## River Road to Rivergate Drive Study Recommendations

## Key Recommendations

River Road just east of Minnetonka Street - both boulevards have space for sidewalks and/or protected bike lanes.

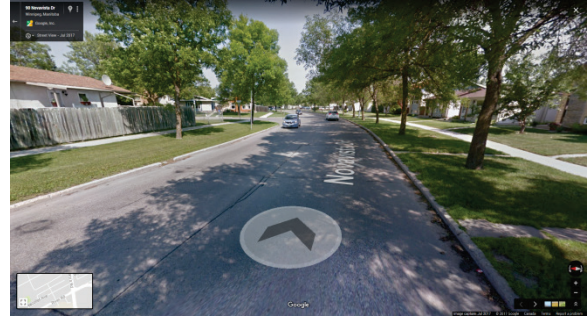
As such, we strongly recommend that the study abandon the idea of a shared-use pathway on River Road in favour of a new sidewalk on the south side of River Road for those on foot, combined with protected bike lanes on River Road for people on their bikes.
